**FOUNDATION INVESTIGATION REPORT  
FOR  
TOWER ROAD UNDERPASS  
W.P. 399-97-01  
G.W.P. 290-97-00, SITE 42-321  
HIGHWAY 69, DISTRICT 52  
HUNTSVILLE, ONTARIO**

**FOUNDATION DESIGN REPORT  
FOR  
TOWER ROAD UNDERPASS  
W.P. 399-97-01  
G.W.P. 290-97-00, SITE 42-321  
HIGHWAY 69, DISTRICT 52  
HUNTSVILLE, ONTARIO**

Re: Final Foundation Investigation Reports  
Hwy 69 - Four Laning From Tower Rd. Northerly 26.5 km to North of Hwy 141  
Blackstone/Crane Lake Underpass, W.P. 408-97-01, Site 44-383  
CNR Overhead, W.P. 405/406-97-01, Site 44-381 N&S  
Healey Lake Road Underpass, W.P. 400-97-01, Site 44-377  
Tower Road Underpass, W.P. 399-97-00, Site 44-321  
Airport Road Underpass, W.P. 407-97-01, Site 44-382  
G.W.P. 290-97-00, Hwy 69, District 52, Huntsville

Re: Draft Foundation Investigation Reports  
Highway 69 - Four Laning  
From Tower Road Northerly 26.5 km to 2 km North of Hwy 141  
Blackstone/Crane Lake Underpass, W.P. 408-97-01, Site 44-383  
CNR Overhead, W.P. 405/406-97-01, Site 44-381 N&S  
Healey Lake Road Underpass, W.P. 400-97-01, Site 44-377  
Tower Road Underpass, W.P. 399-97-00, Site 44-321  
Airport Road Underpass, W.P. 407-97-01, Site 44-382  
G.W.P. 290-97-00,

**BOREHOLE LOCATION PLAN  
AND SOIL PROFILES**

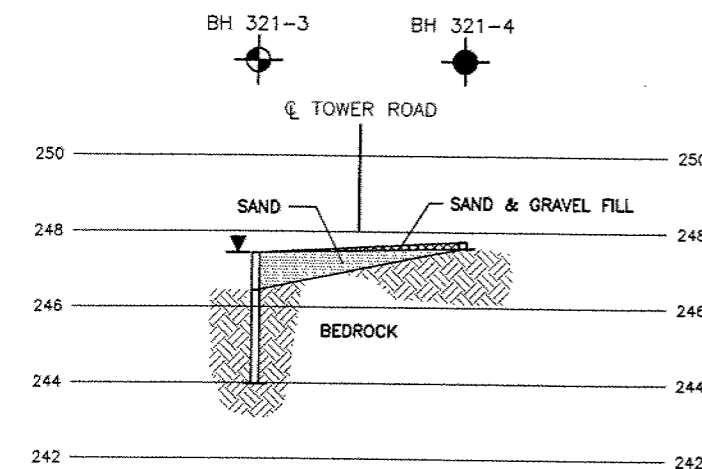
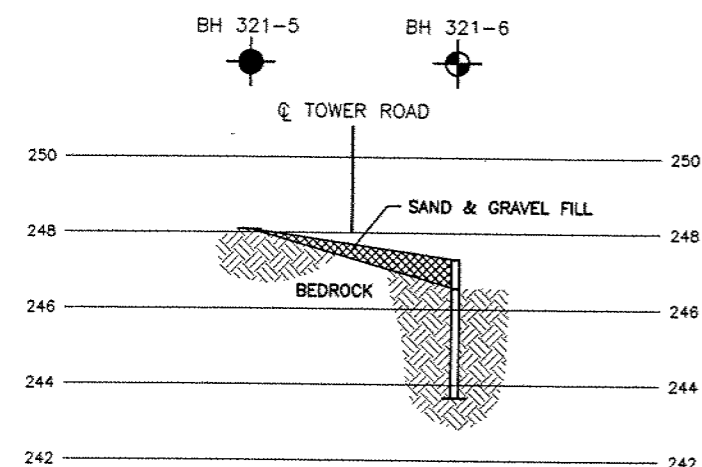
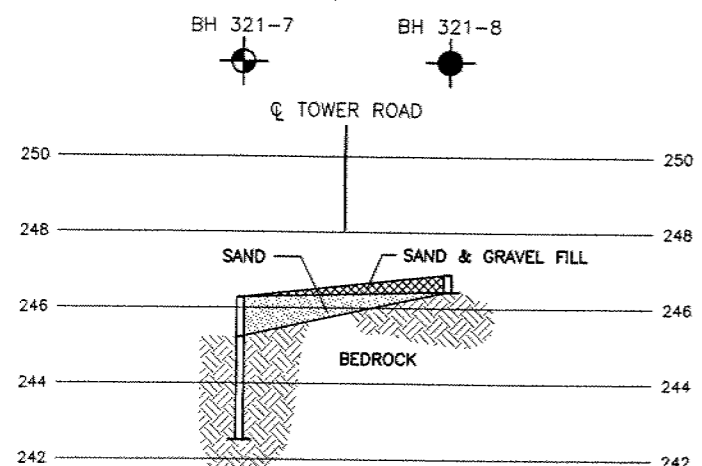
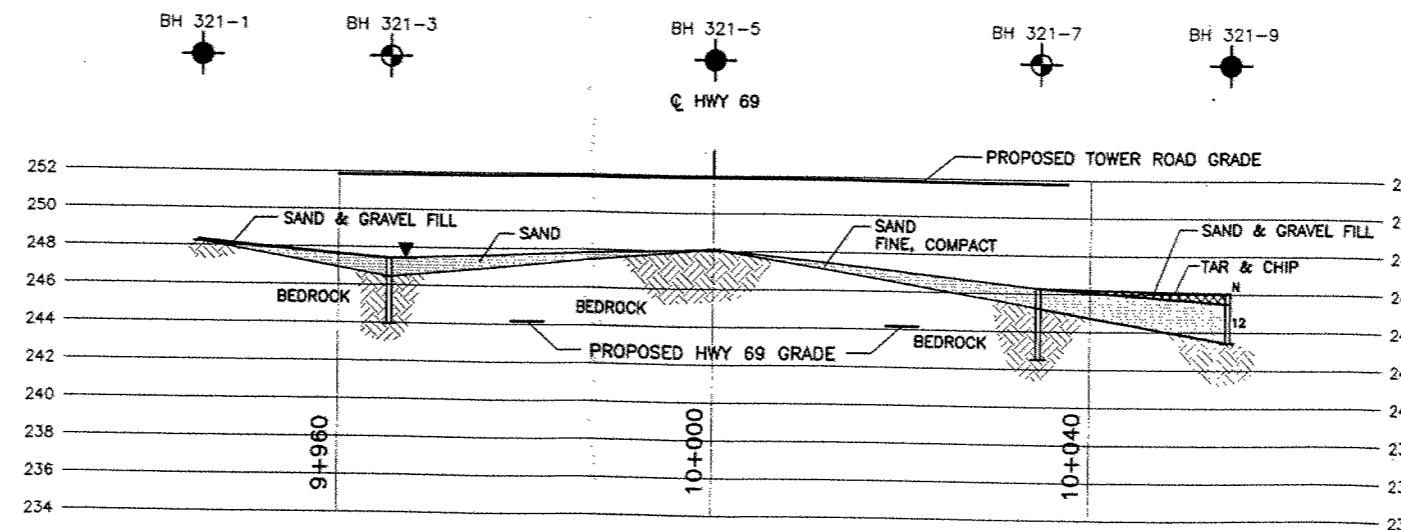
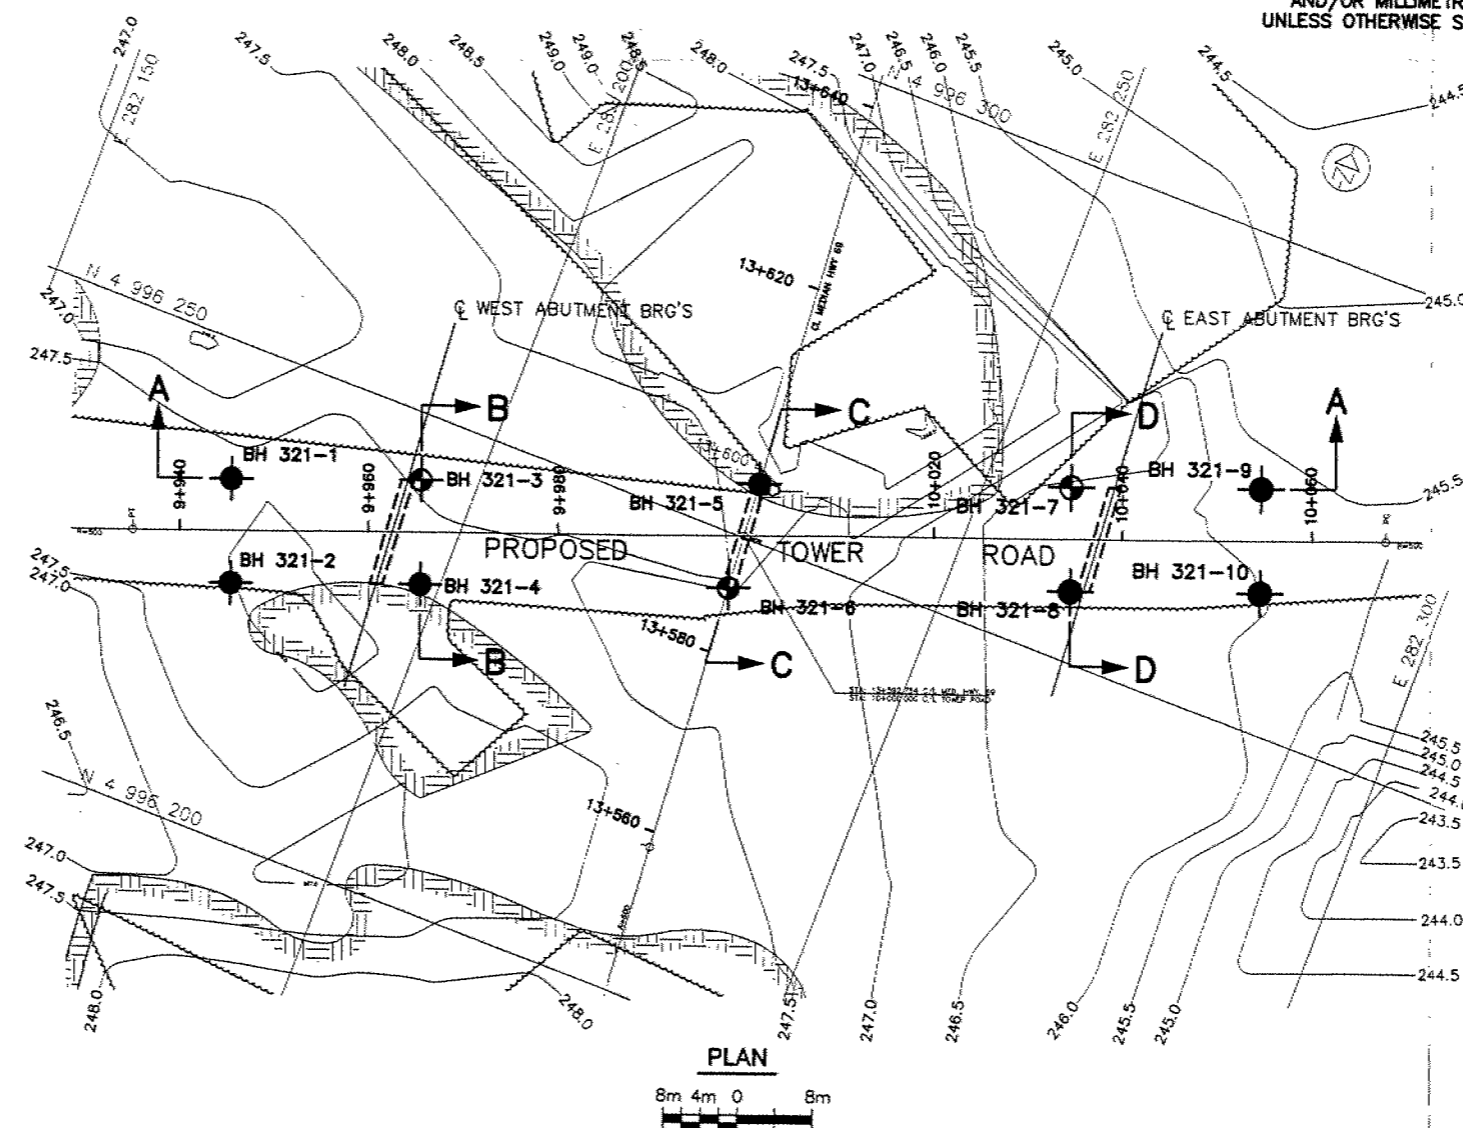
2. Recommendation should be given for the side slopes of the approach fills.
3. The Key Plan, northing and easting and the stations shown on the plan are very small. After the drawings are reproduced to include in the contract package, they would not be legible.

4. The cross sections are very small (some of them are thumb size) and should be enlarged. These cross sections will be included in the contract package. When they are reproduced for the contract package, they would not be legible. The plan is produced in 1:500 scale. The cross sections are normally 100 percent larger than the plans to show the details. But in the report the cross sections are 50 percent reduced. Ideally the cross sections should be in true scale, i.e. same horizontal and vertical scales. If the true scale is not feasible, then the ratio of horizontal and vertical scales should be 2. The ratio of the horizontal and vertical scale in the foundation reports are 5. The cross sections, therefore, are very distorted. All the cross sections do not have to fit on one drawing. Cross sections can be produced on more than one drawings. A sample copy of the standard drawing can be obtained from the Pavements and Foundations office.

5. A bar scale, similar to the one provided on the plan should also be provided on the cross sections
6. The Pavements and Foundations Section has assigned Geocres Numbers for these projects. The Consultant should provide the Geocres numbers on the Final Reports. The Geocres number shall be shown on the lower left corner of the Title Page of the Foundation reports.
